# Kyoto **energypark**

## Supplement to Environmental Assessment Responses to Public Submissions

**Responses to the Public submissions received during public exhibition of the Kyoto Energy Park proposal in accordance with Part 3A of the Environmental Planning and Assessment Act 1979.**

Figure 1.3 Location of Aboriginal Objects in relation to Middlebrook Station (Myall Coast Archaeological)

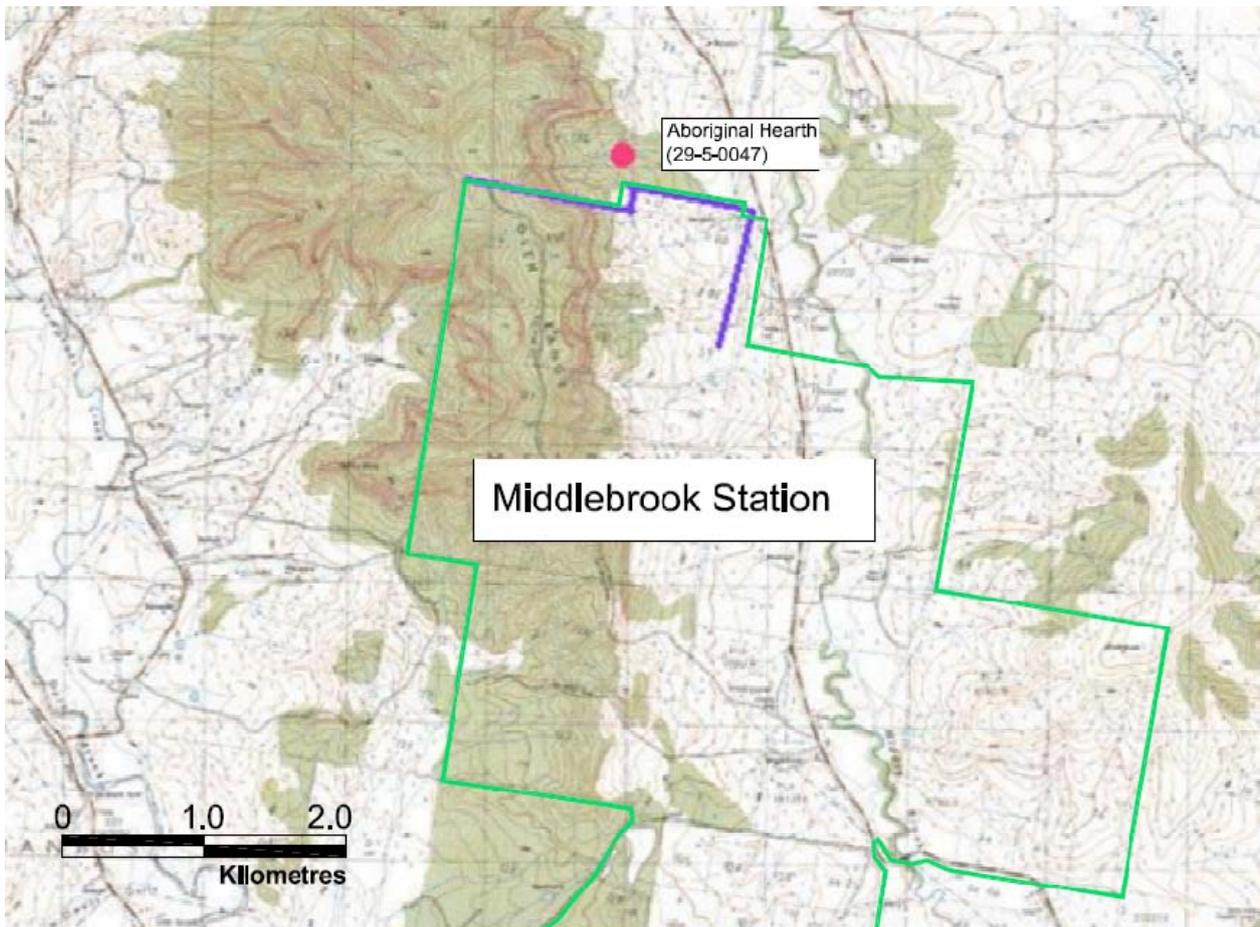
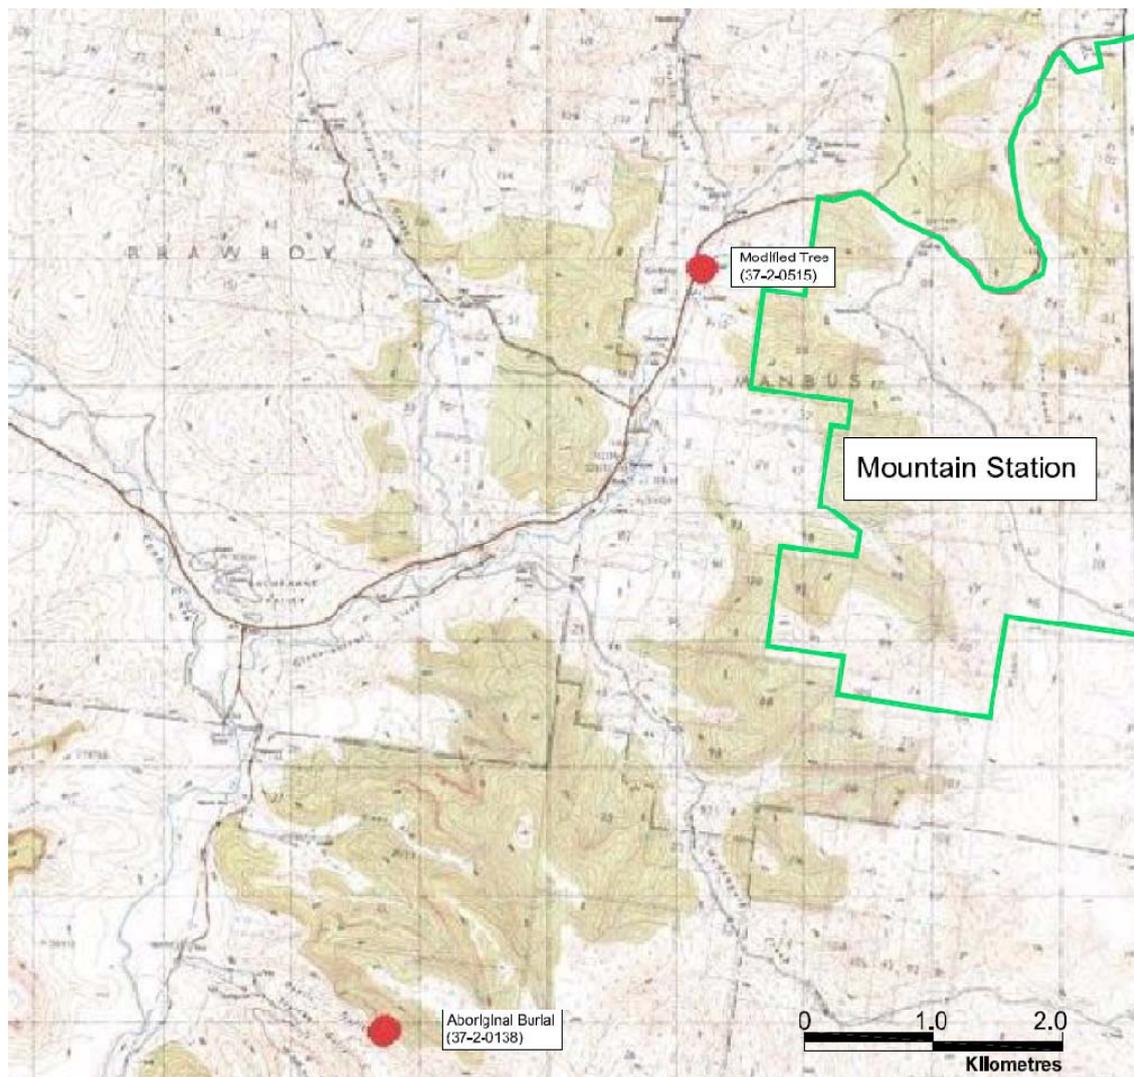
The DECC have referred to three known Aboriginal Objects known as an Aboriginal Burial (37-2-0138), a modified tree (37-2-0515), and an Aboriginal Hearth (29-5-0047). With respect to the objects specifically referred to in the comments from DECC they have been marked on the following map supplied by Myall Coast Archaeologists (see Figure 1.3 and 1.4 below). The modified tree and Aboriginal burial were considered in the EA submitted for public exhibition and are actually some 2.3km to 4.5km from the closest turbines respectively. These items are outside the limits of the site boundaries as shown in the figures below and therefore are not considered to be in the close vicinity.

The burial in question (Figure 1.3 below) is located near water and in a completely different landscape. This particular burial is typical of the characteristics required for burials as discussed in the report and was taken into account. It was not specifically mentioned as it was 4.5km away and bore no special relevance to the study area as described above.

The Aboriginal Hearth (fireplace) is located north of Middlebrook Station as shown in Figure 1.4. It is approximately 500m to the north of the northern property boundary and approximately 3.3km from the closest proposed turbine in a straight line. However it cannot be accessed from the ridgeline in a straight direction as it is on a footslope some 250 metres below a steep escarpment. This object was not identified on the original searches. It could be because it was outside the initial search, however should have shown up on the 20km search.

Figure 2.0 Final Layout of Proposed Facilities (Mountain Station)

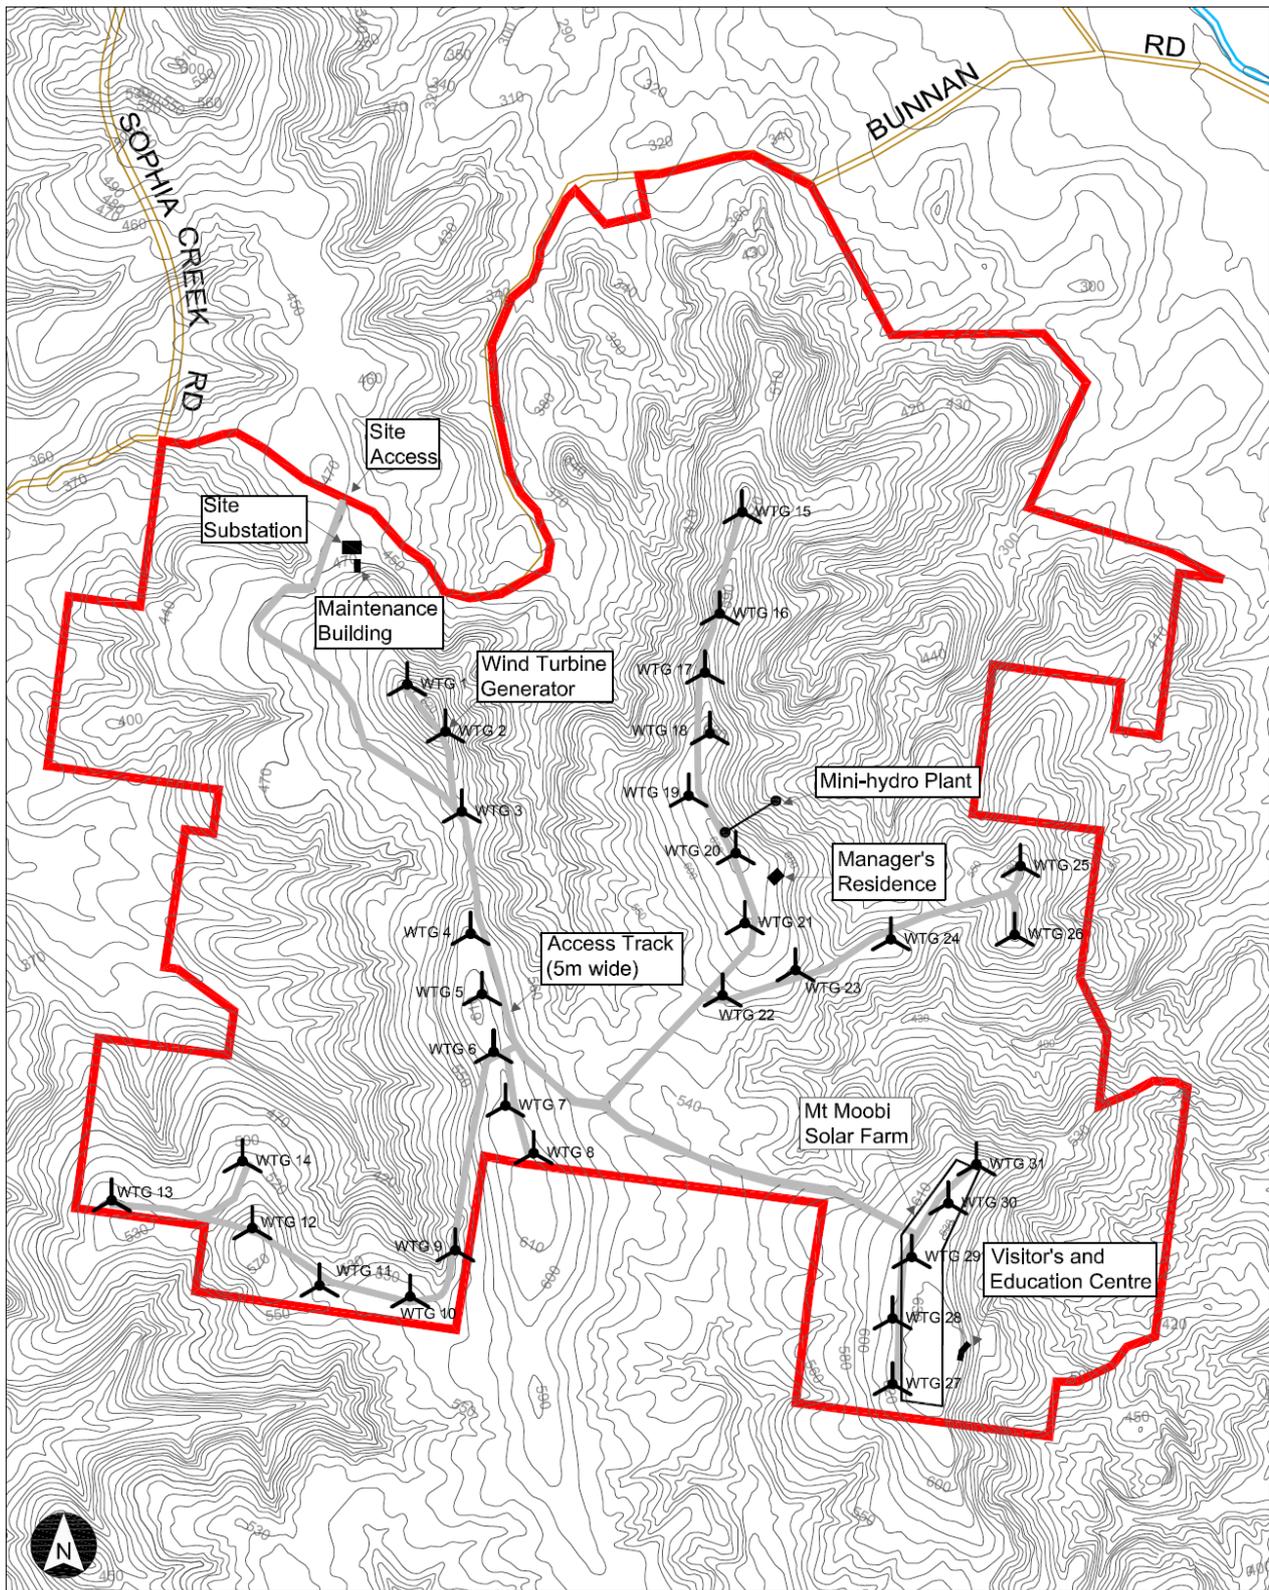
- Reduction in the overall Visual effect of wind turbines and Visual Impact on residents identified in highly impacted areas, particularly south and directly west of Middlebrook Station and also directly east of Mountain Station. These areas have been identified as having the greatest degree of visual impact from turbines (see Figure 11.4 of Volume 1 of the EA –Visual Impact Map) and include areas generally in Thompson’s Creek Road, Lower Sparkes Creek Road, Dartbrook Road and also in the vicinity of Moobi Road.

Following receipt of all public submissions and responses from Government authorities, a preferred layout is provided below. Based on further technical advice and investigation of impacts a total of 8 wind turbine generators (WTGs) have been removed from the EA proposal that was placed publically exhibited.

Proposed facilities on Mountain Station are illustrated in Figure 2.0.

Figure 2.1 Final Layout of Proposed Facilities (Middlebrook Station)

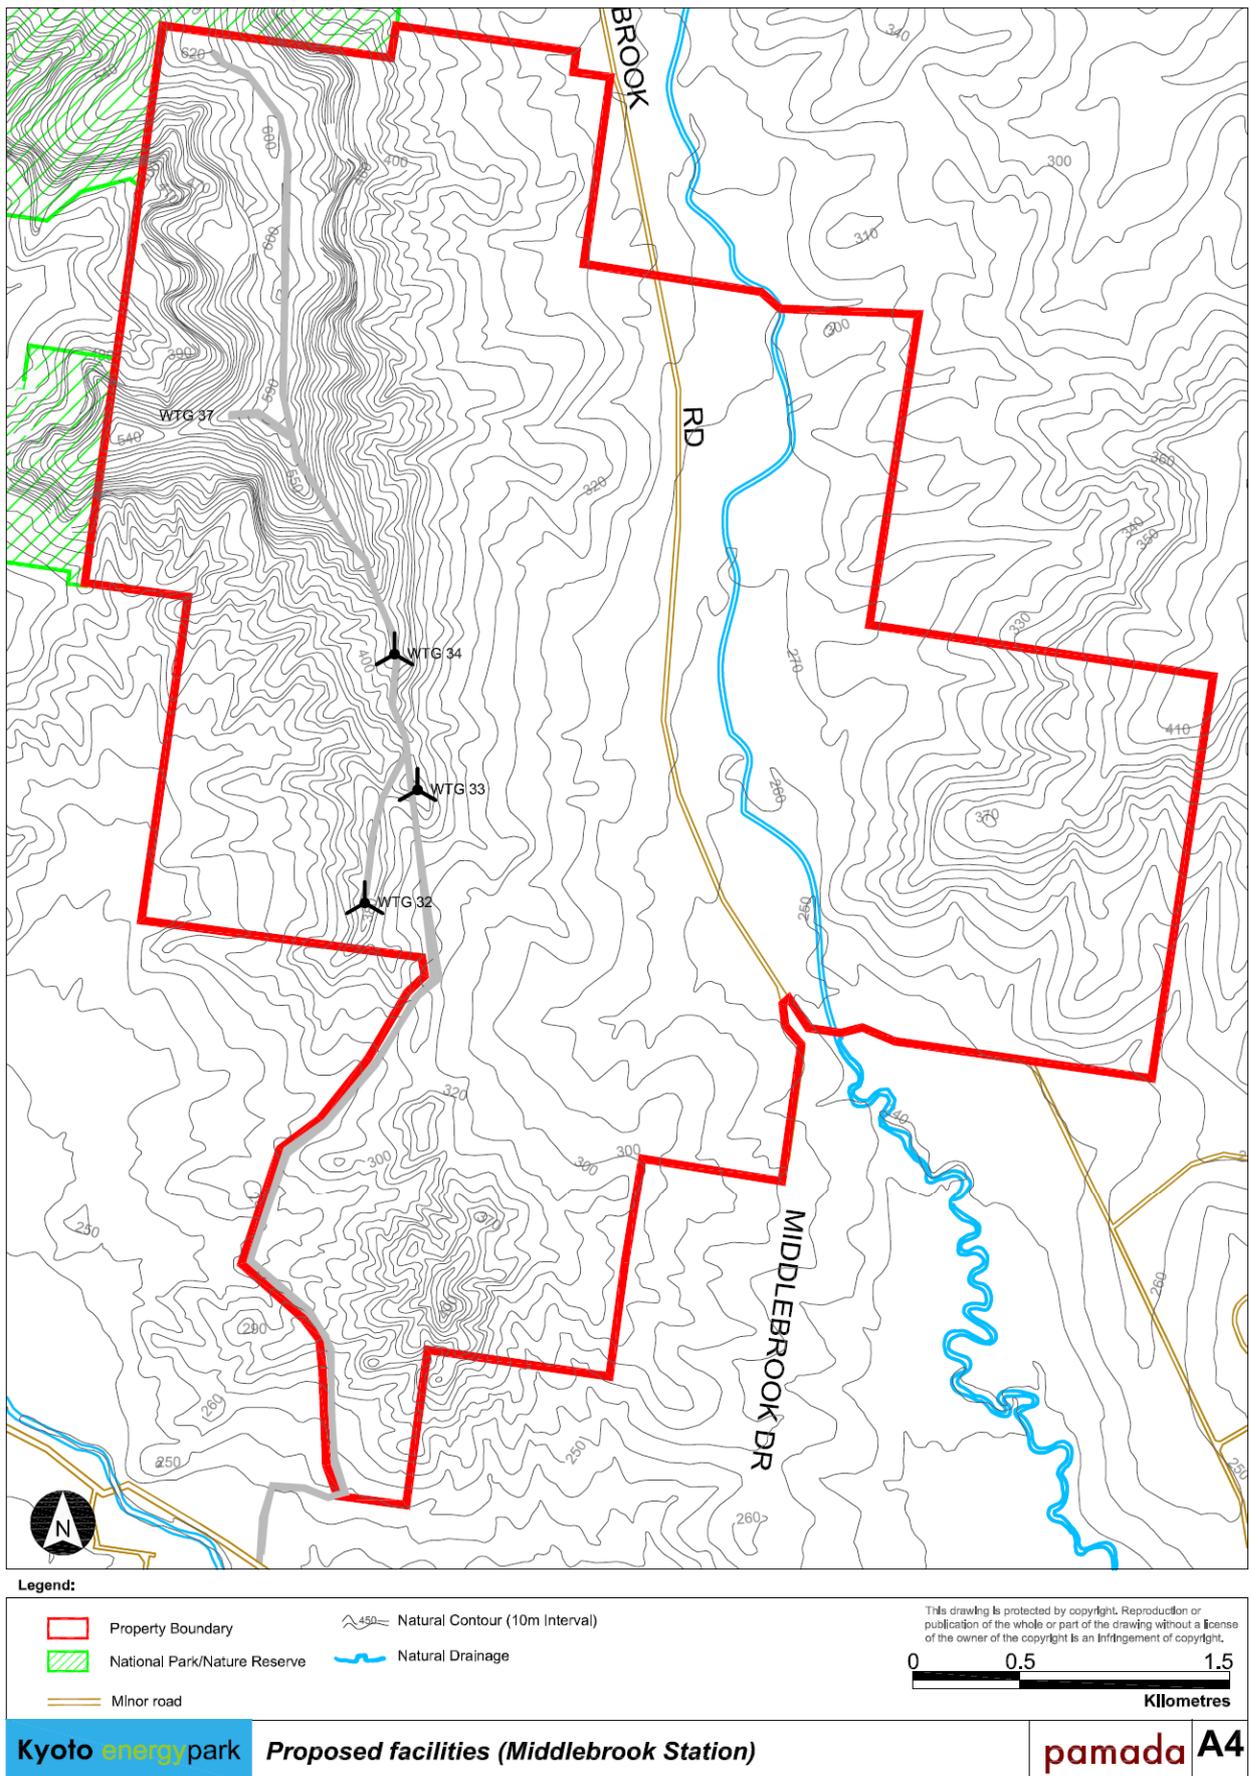
As of July 2009 Pamada have resolved to remove an additional 8 turbines from the Glen Range ridgeline behind the Castle Rock formation. Significant numbers of concerns were received from residents directly west of the Castle Rock formation and Middlebrook Station during exhibition of the EA. Removing these additional turbines would eliminate the visual integration concerns when viewing the Castle Rock formation from a west and south west position. Other distinctive rocky formations were identified along this western escarpment, mainly to the north of Castle Rock. Castle Rock is not a recognised tourist attraction currently within the area.

It is proposed to remove 8 turbines from the Middlebrook Station site closest to Towarri National Park (see Section 3.0 – Final Layout). Removal of these turbines from the proposal will significantly reduce the amount vegetation modification, clearing and disturbance on Middlebrook Station in closest proximity to Towarri National Park.

Proposed facilities on Middlebrook Station (revised) are illustrated in Figure 2.1 above.
